INTRODUCTION

OUTLINE OF NEW FEATURES

The following changes have been made:

1. Exterior

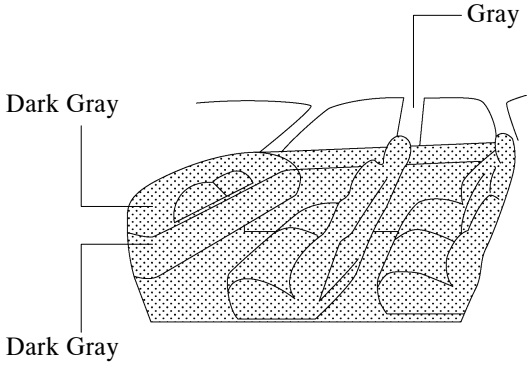
- The exterior of the front and rear has been changed. For details, see page 11.
- The exterior colors have been changed as follows:

2. Interior

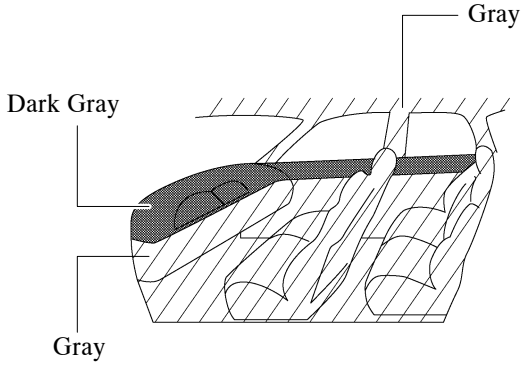
- The interior colors have been changed as follows:

*: The location of the colors differs between dark gray and dark gray/gray.

▶ Table of Seat Fabric ◀

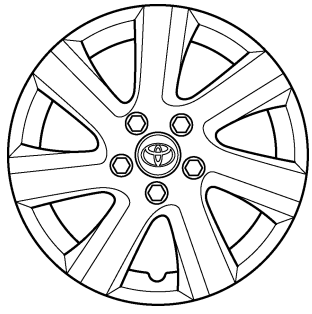
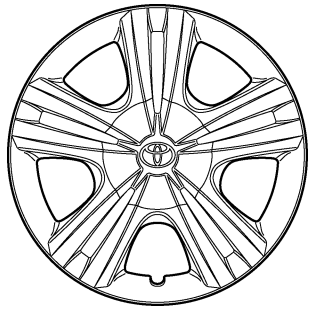
Item	Changed	Camry	Aurion
Instrument Panel and Trim Woodgrain	The instrument panel and trim woodgrain have been changed from the high gloss (22BN61) to the semi gloss (22BN75).	-	×
Seatback Pocket	The seatback pocket has been changed to hard board type for enhanced appearance.	×	-
Seat Fabric	The seat fabric design has been changed. For details, refer to the table on the next page.	×	×
Ashtray	**Models for Australia:** • The ashtray has been discontinued.	×	-
	Models for G.C.C. Countries: • The ashtray has been changed from the pullout type to a removable cup that can be installed to the cup holders.

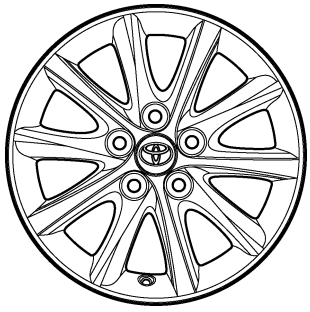
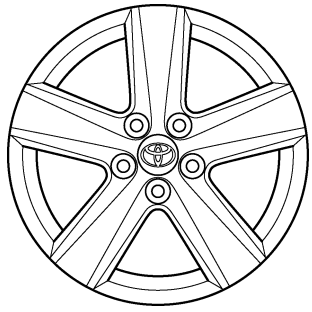
- The wheel cap, 16-inch and 17-inch wheels have been changed for Camry.

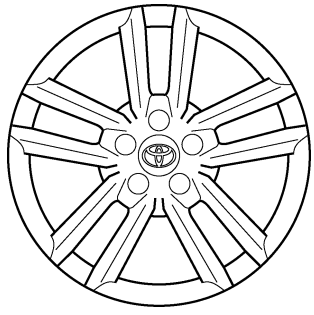
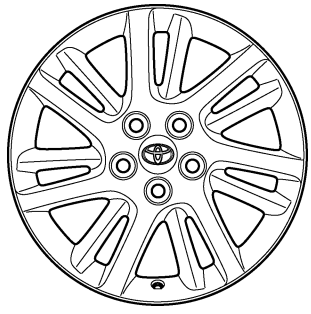
- The 16-inch and 17-inch wheels have been changed for Aurion.
